Re: Third Submission Review: Green Valley Ranch East – Site Plan No. 19, Plat Vacation and Plat
Application Number: DA-1662-35
Case Numbers: 2021-4010-01; 2021-3017-01; 2024-3030-00

Third Submission Review

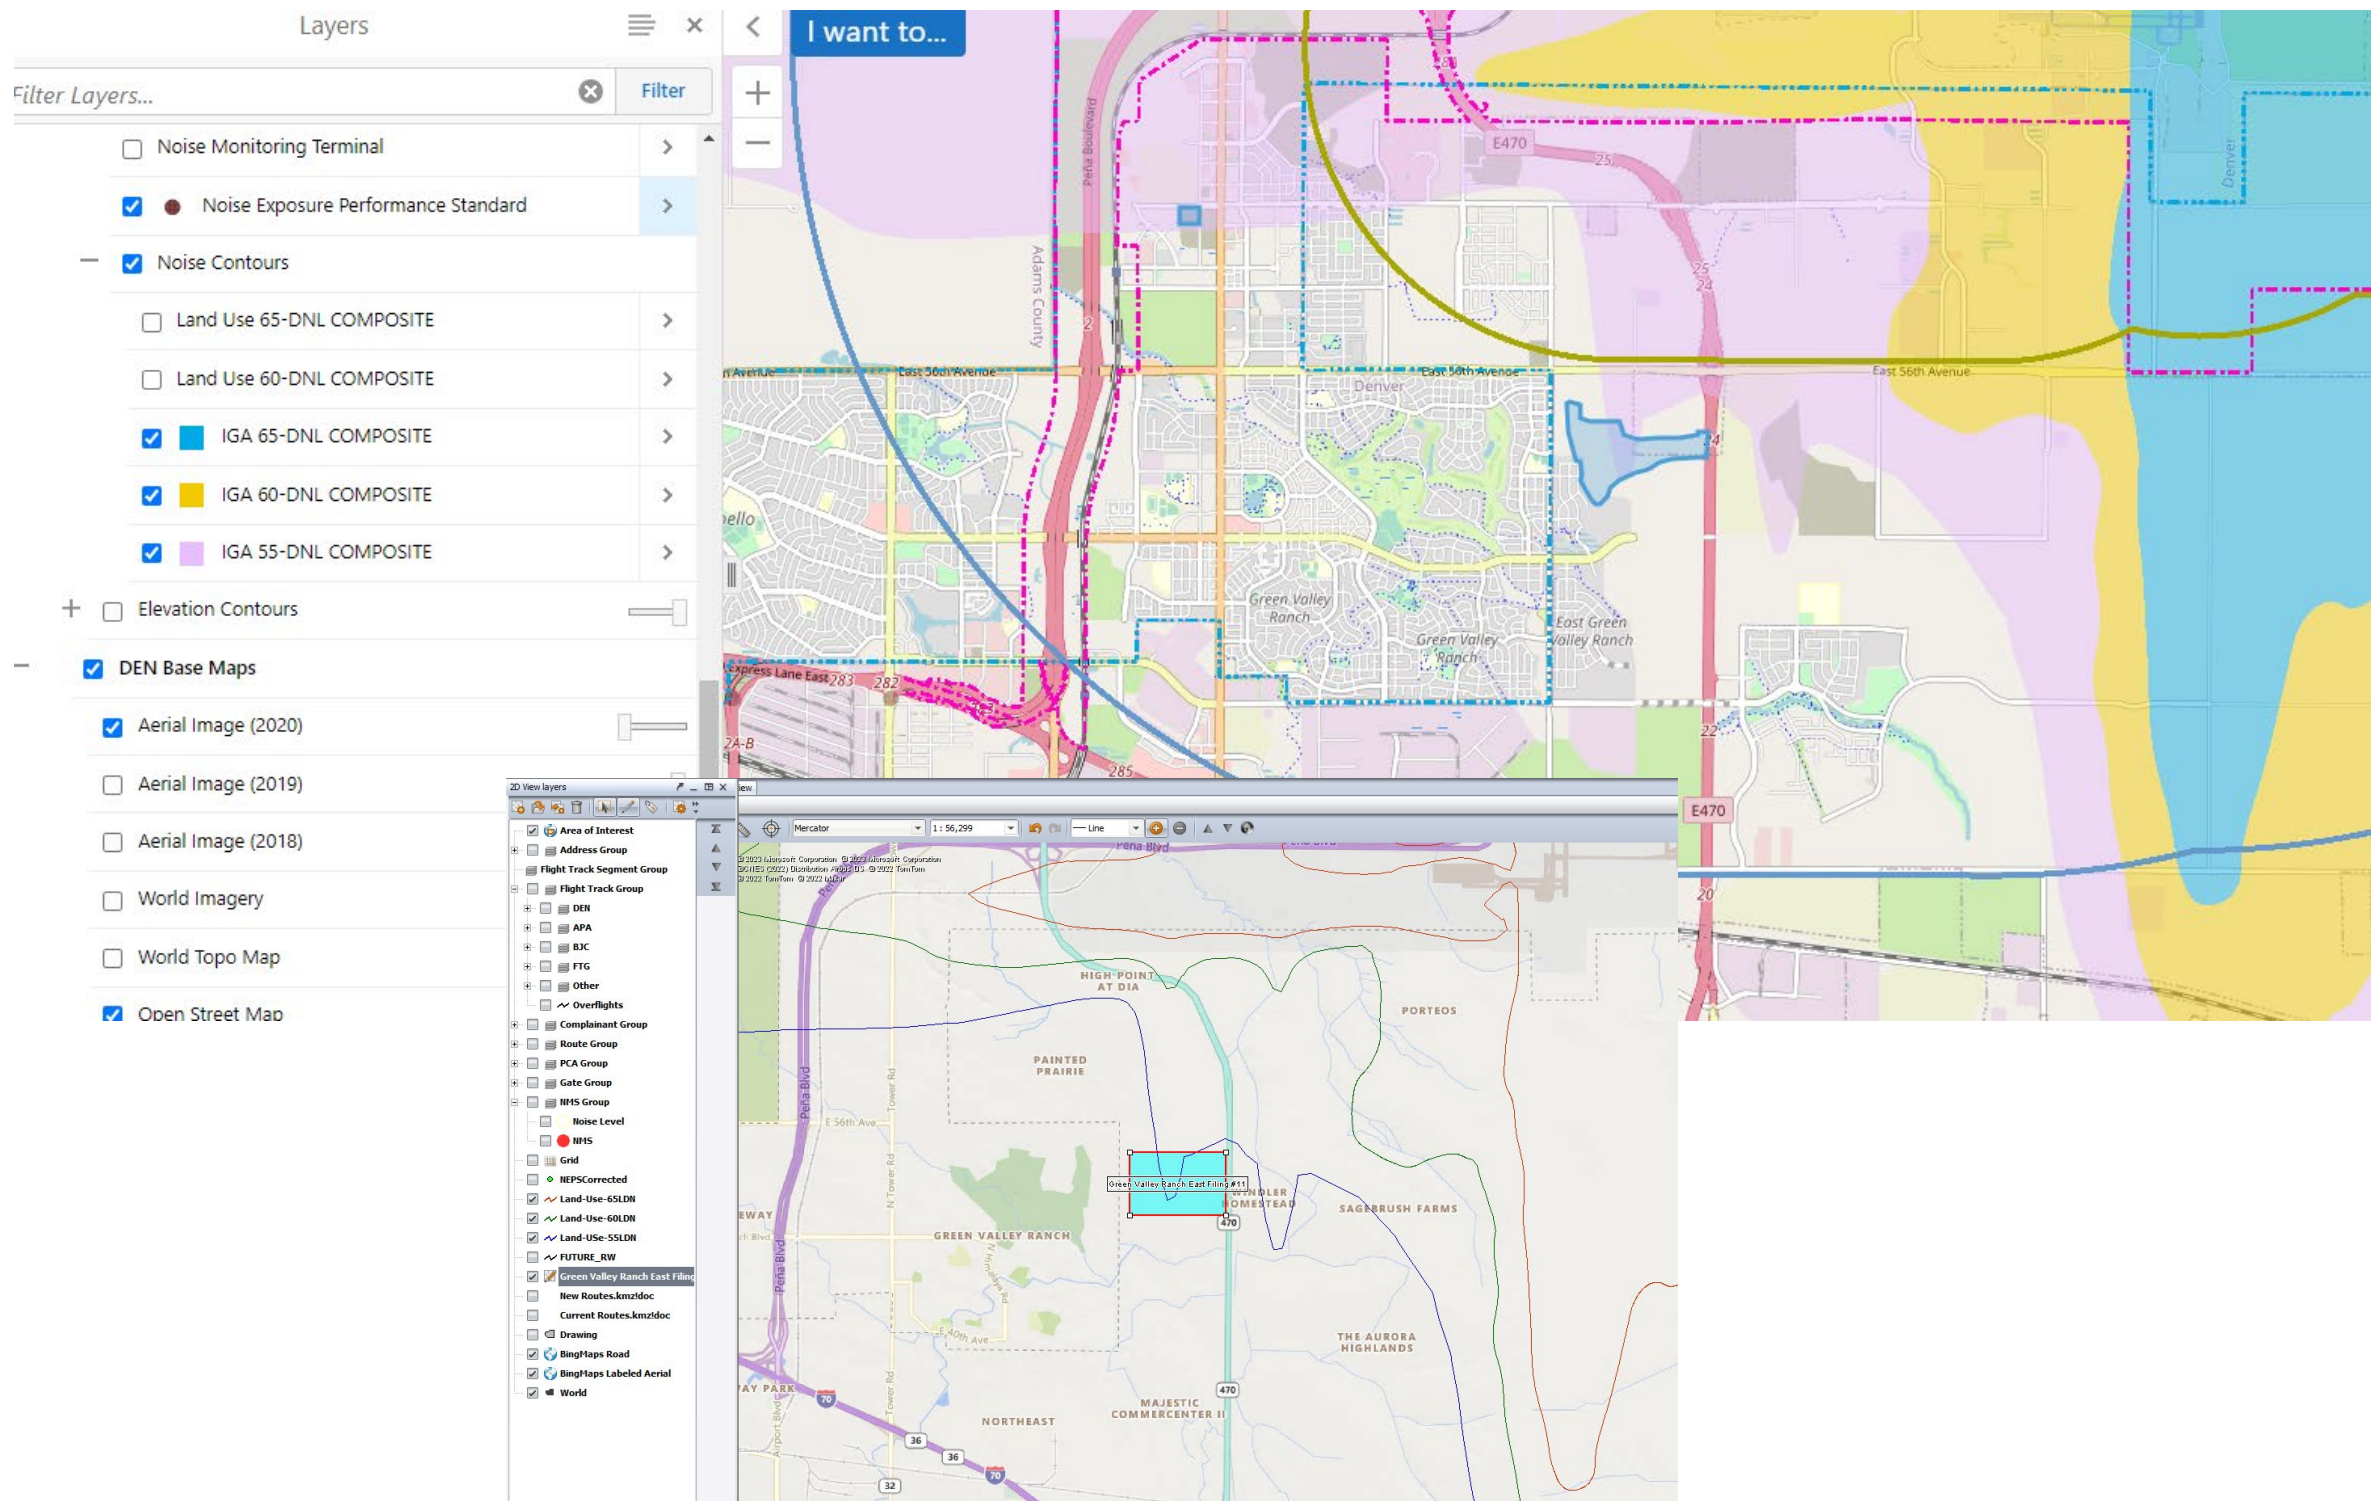
Public Service Company of Colorado's (PSCo) Right of Way & Permits Referral Desk is still unclear as to why PSCo's 6-foot-wide standard easement width for natural gas distribution facilities is not implemented throughout the plat.

Please work with the Designer assigned to the project for further conversation as noted in the comment response.

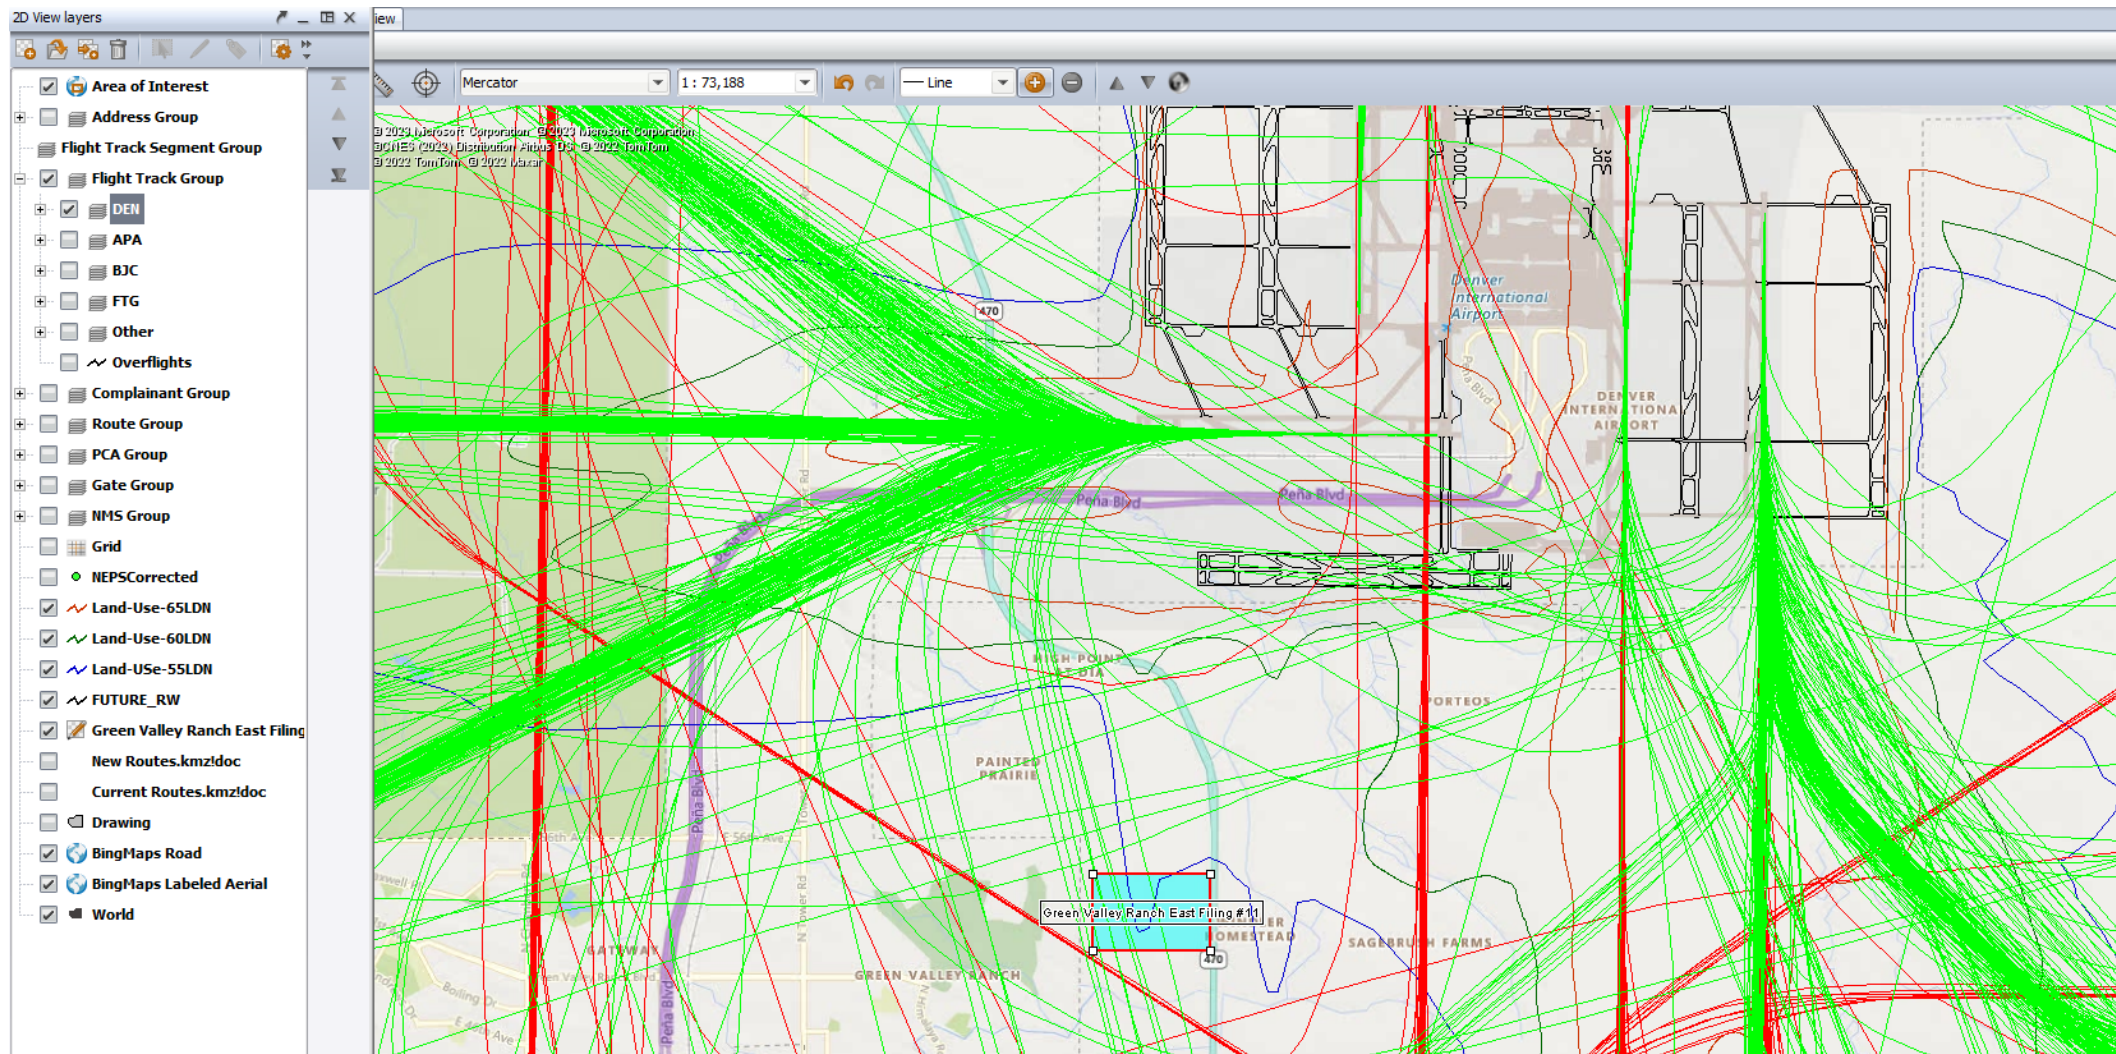
Other developments in this area have been reviewed previously, and the noise analysis still holds true. While this area is not currently under an arrival pattern, the future north south runways on the west side of the airfield will put arrivals over the subject property. This portion of the development could potentially have arrival overflights from the south at altitudes of between 1,500 feet above ground level (AGL) and 4,100 feet AGL depending on the aircraft type and what arrival runway the Federal Aviation Administration (FAA) air traffic controllers have directed the aircraft to land on. If the winds are out of the north aircraft will land coming in from the south on final approach to DEN. Aircraft currently arrive to DEN on runways 34L and 34R and with the potential of 4 North/South runways on the West side of the airfield there could be even more daily arrival overflights of this development. The future runways are depicted in black on this map of flight data from 2/28/23. This days of flights depicts a typical flight pattern for a 24 period.

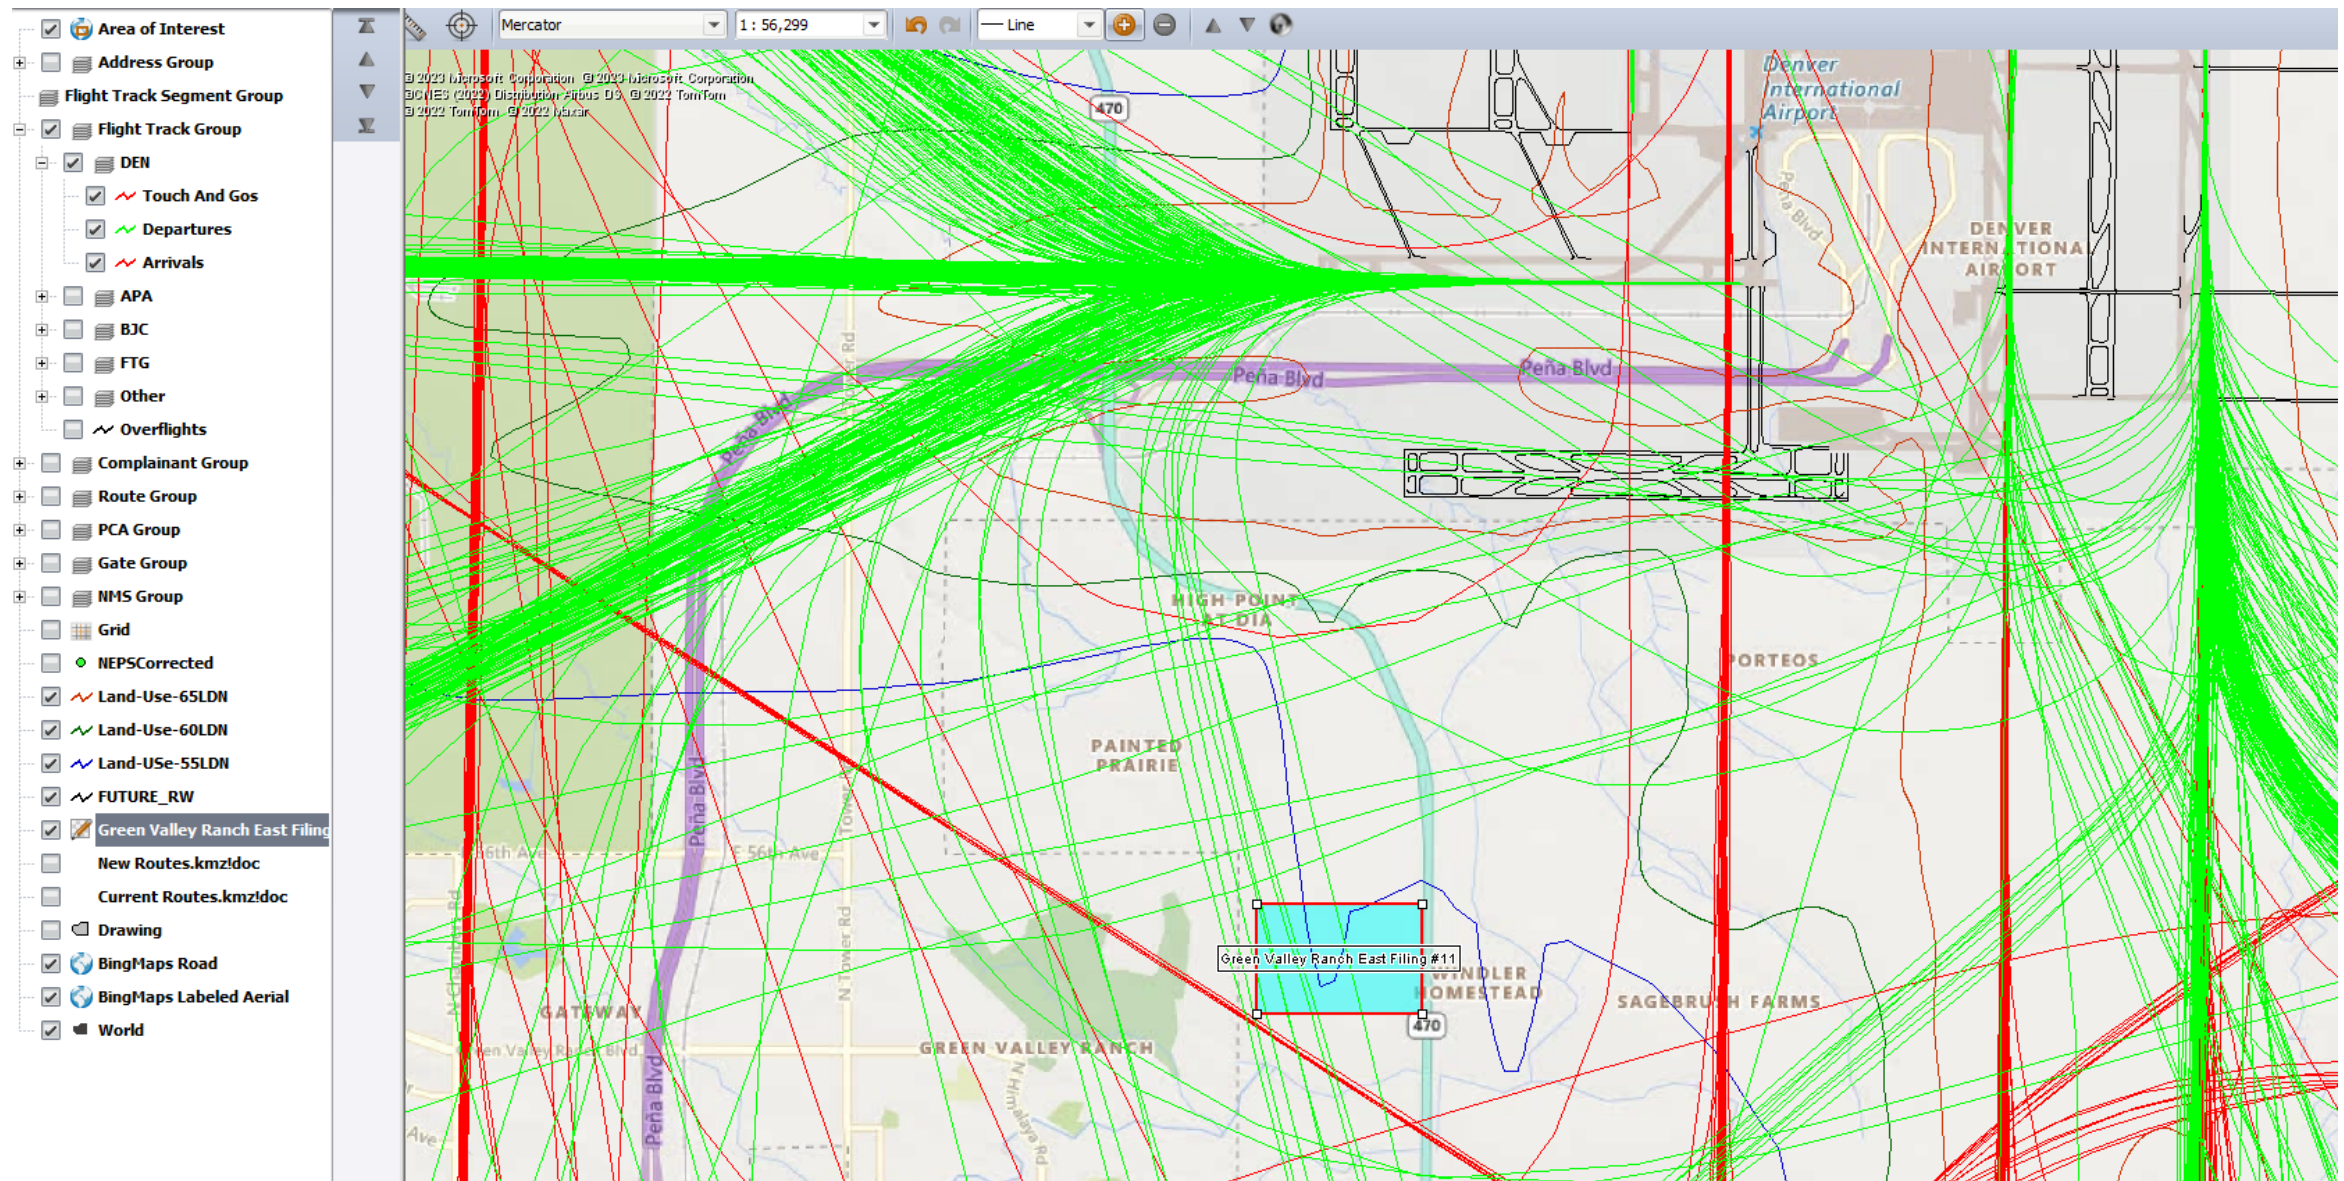
Same flight data from 2/28/23, zoomed in to see the 55, 60 and 65 DNL contour and the property area in light blue. The 55 DNL intersects the property on the north end. This portion of the 55 DNL pertains to the additional 2 potential north/south runways on the west side of the airfield. Once the runway straight north of this property is built, 16C/34C (might be the runway names) there will be overflights at the beforementioned altitudes. There could be upwards of 200+ arrivals per day to those future runways.
